WELL API NO. 30.025.32532
5. Indicate Type of Lease STATE <input checked="" type="checkbox"/> FEE <input type="checkbox"/>
6. State Oil & Gas Lease No.
7. Lease Name or Unit Agreement Name BERTHA BARBER
8. Well Number #015
9. OGRID Numer 873
10. Pool Name or Wildcat Eumont; Yates, 7Rvrs-Queen (Gas)

SUNDRY NOTICES AND REPORTS ON WELLS

Apache Corporation proposes to P&A the above mentioned well by the attached procedure. A closed loop system will be used for all fluids from this wellbore and disposed of required by OCD Rule 19.15.17.14 NMAC.

**CONDITIONS OF APPROVAL
FOR PLUGGING AND ABANDONMENT
OCD - Southern District**

LEASE NAME	BERTHA BARBER
WELL #	#015
API #	30.025.32532
COUNTY	LEA, NM

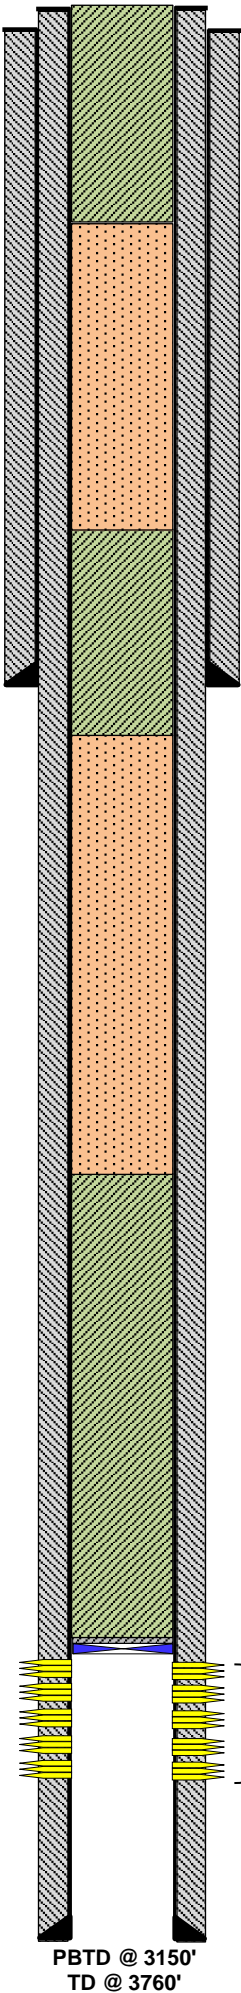
DEPTH	SX/CMT	PROPOSED PROCEDURE
SURF		
25 SX		3. PUH & SPOT CLASS "C" CMT TO SURF, FILL UP.
300'		WATER BOARD & SURF PLUG
930'		
25 SX		2. PUH & SPOT CLASS "C" CMT, WOC/TAG
1280'		SURF SHOE & TOP OF SALT
2316'		
60 SX		1. MIRU P&A RIG. RIH W/TBG & VERIFY CIBP, CIRC W/MLF, & SPOT CLASS "C" CMT,
3150'		EUMONT PERFS, 7 RVRS, YATES BASE OF SALT
Eumont perfs @ 3207'-3436'

11. Class 'C' cement will be used above 7500 feet.
12. Class 'H' cement will be used below 7500 feet.
13. A cement plug is required to be set 50' above and 50' below, casing stubs, DV tools, attempted casing cut offs, cement tops outside casing, salt sections and anywhere the casing is perforated, these plugs require a 4 hour WOC and then will be tagged

14. All Casing Shoes Will Be Perforated 50' below shoe depth and Attempted to be Squeezed, cement needs to be 50' above and 50' Below Casing Shoe inside the Production Casing.
